ORIGINATION FORM

Proposed Revisions to a Standard Plans Index (Please provide all information — Incomplete forms will be returned)

Index Number: 102-600

Index Title: General Information for Traffic Control Through Work Zones

2 POST SIGN SUPPORT MOUNTING DETAILS (SINGLE POST SIMILAR) RURAL

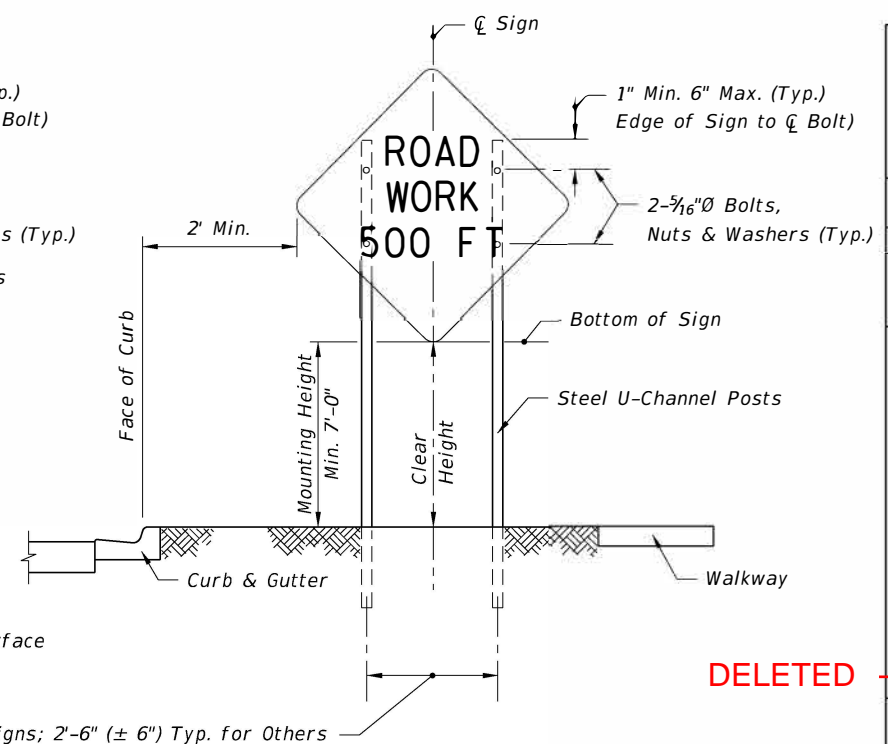
MOVED TO: Table 7 Notes.

MOVED: Note 9 as Note 5 in Table 7

3 POST SIGN SUPPORT MOUNTING DETAILS

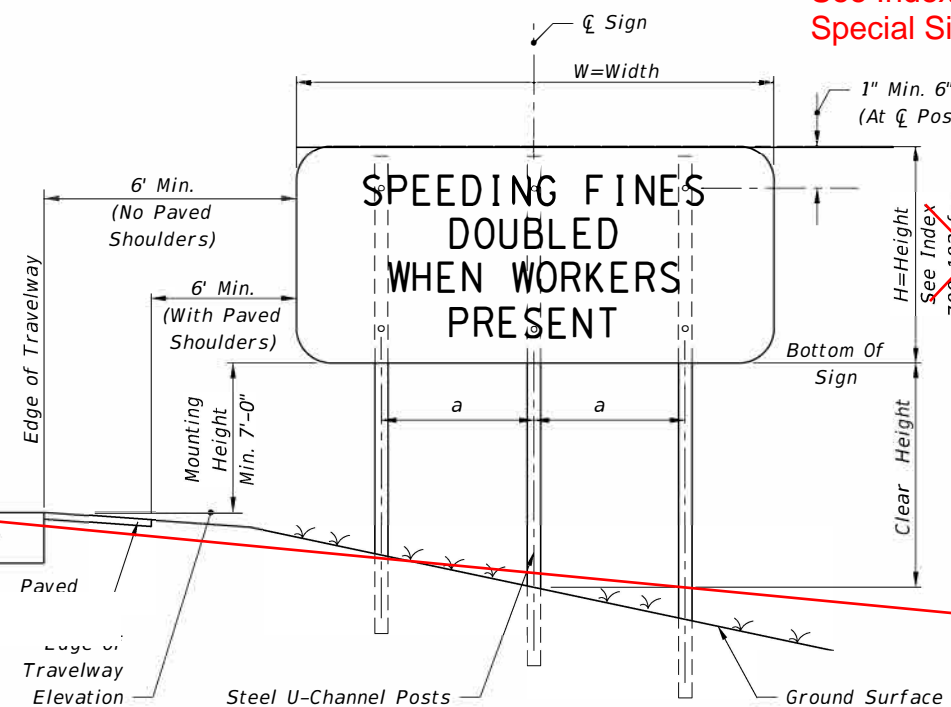
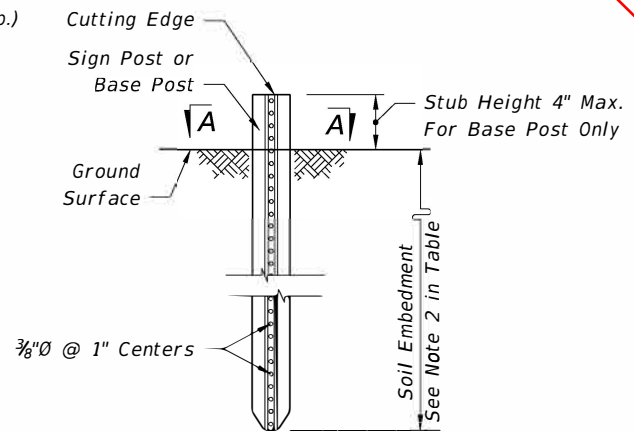
Sheet 5: Changed the Height reference note to "See Index 700-102 for Special Sign Details" and deleted the 60" Width in the 3 POST SUPPOR MOUNTING DETAILS; Moved TEMPORARY SIGN SUPPORT NOTE 9 to TABLE 7, as Note 5; Deleted the 60x64 and the 120x60* Rectangle signs and associated note from TABLE 7; Deleted "(See Note 7)" reference from the Diamond sign in TABLE 7.

Where $W = 48": a = 1' - 4\frac{1}{2}" (\pm 1")$
 ~~$W = 60": a = 1' - 9" (\pm 1")$~~
 $W = 72": a = 2' - 1" (\pm 1")$

Deleted

See Index 700-102 for Special Sign Details

COMMONLY USED WARNING AND REGULATORY SIGNS IN WORK ZONES

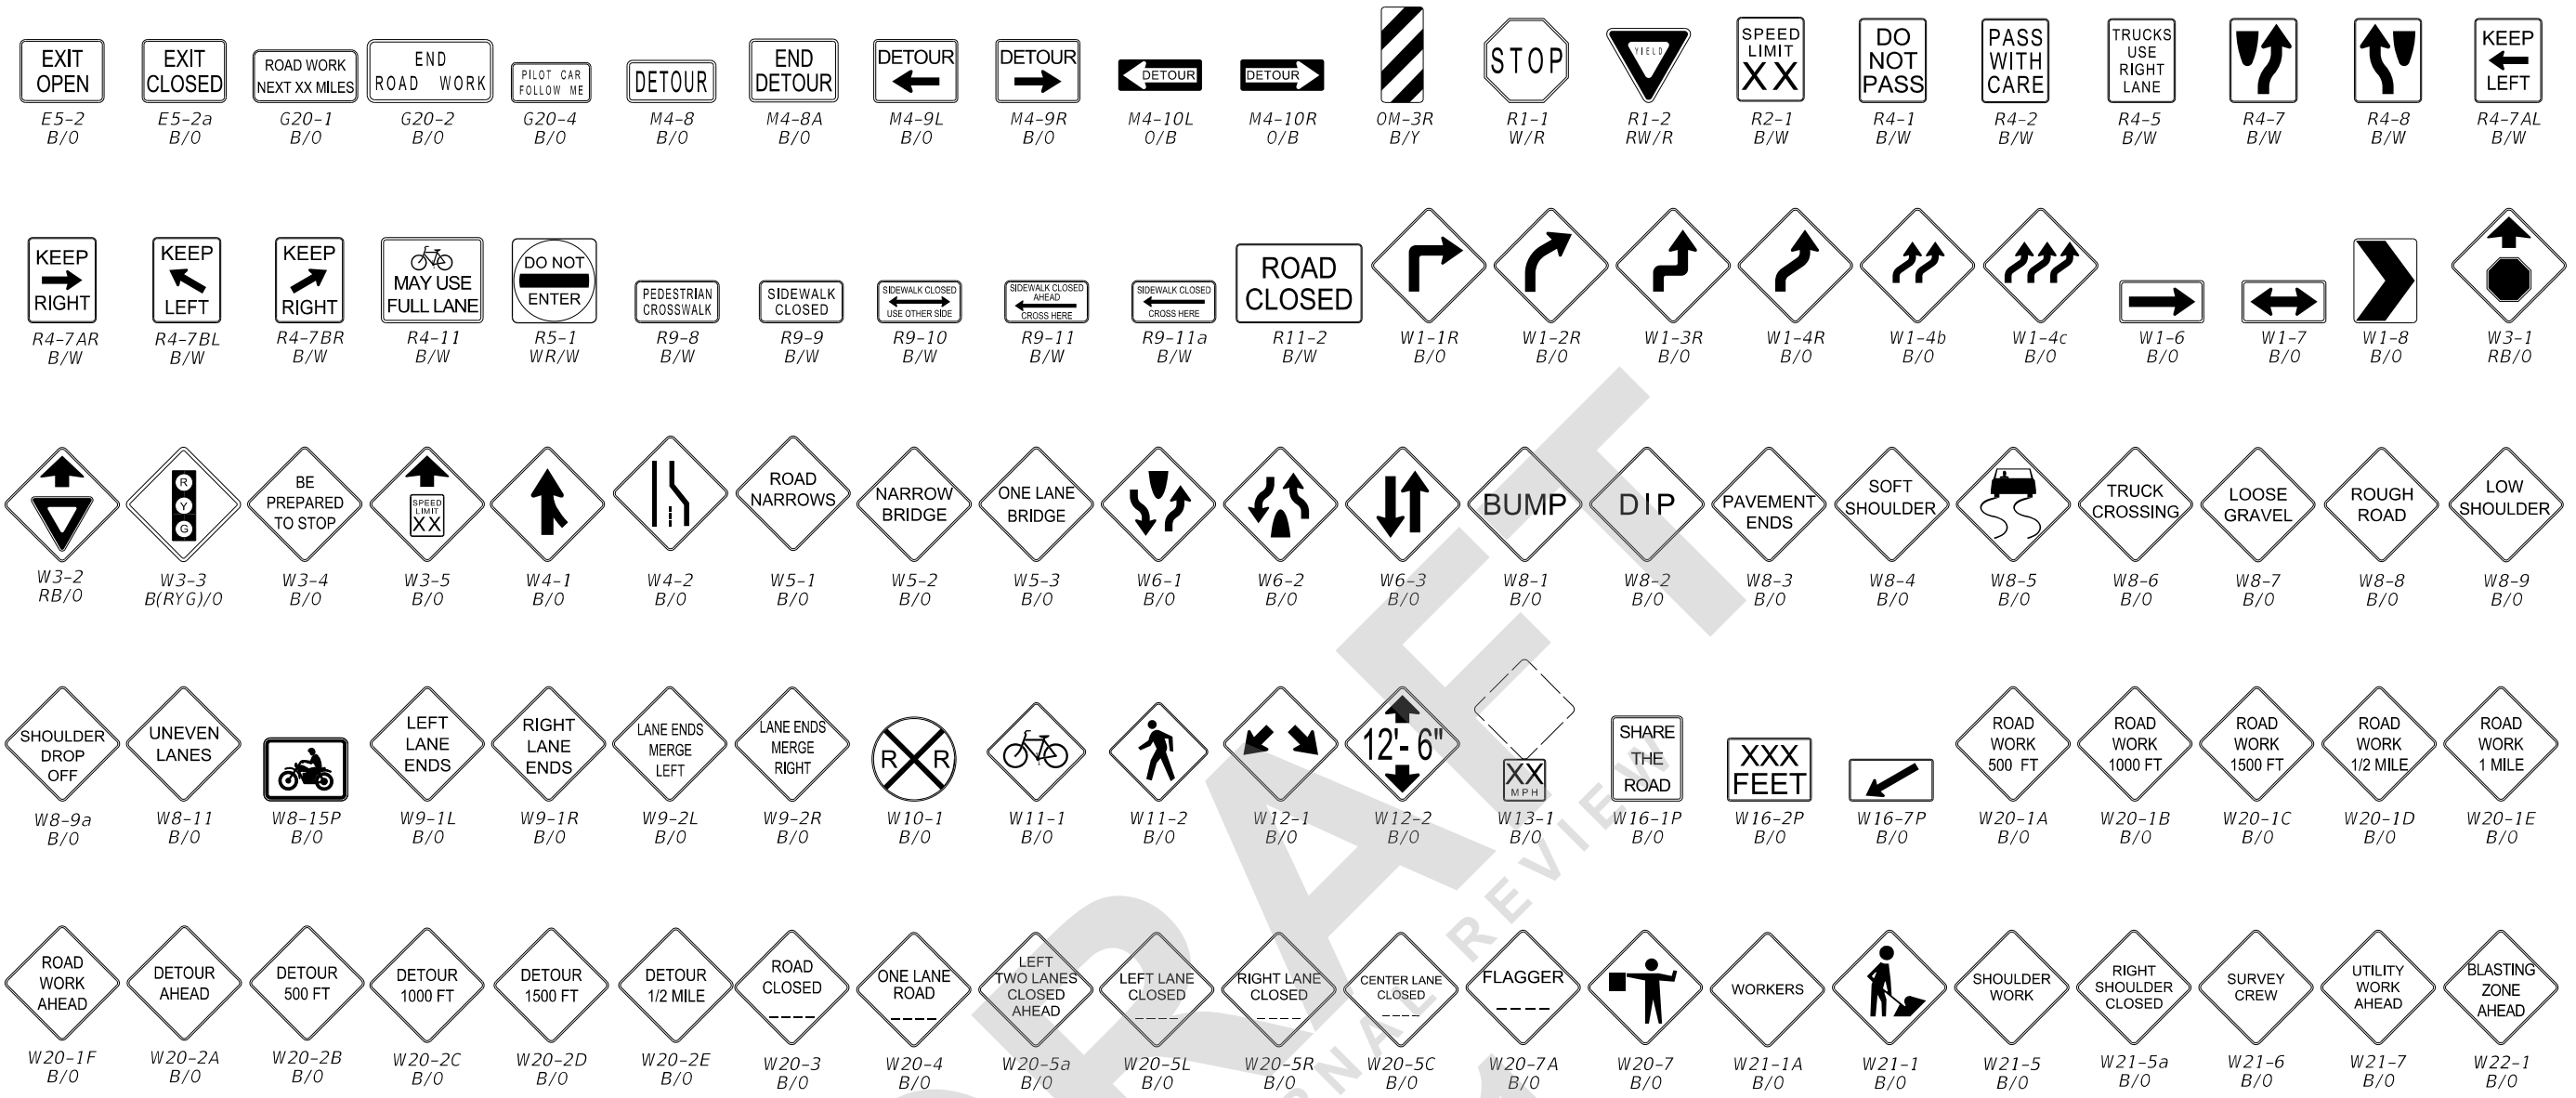
Sheet 6: Rearranged all signs: Added signs: R4-11, W11-1, and W16-1p: Deleted all of the "MOT" signs.

REARRANGED

ADDED SIGNS:
 R4-11
 W11-1
 W16-1P

DELETED ALL OF THE MOT SIGNS

SIDE ROAD INTERSECTING THE WORK ZONE

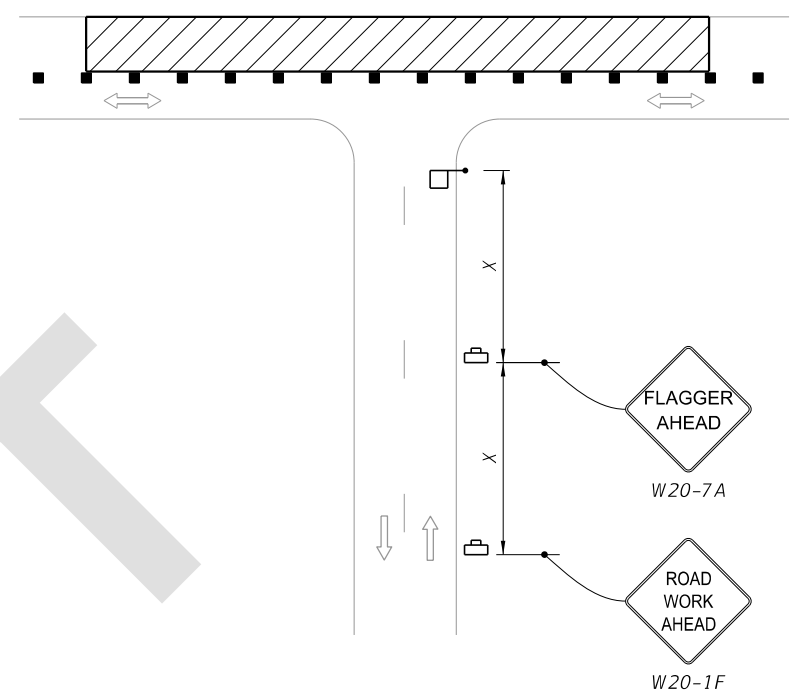
Sheet 7: Added the SIDE ROAD INTERSECTING THE WORK ZONE details form Index 102-606.

**ADDED:
SIDE ROAD INTERSECTING THE WORK ZONE
detail from Index 102-606**
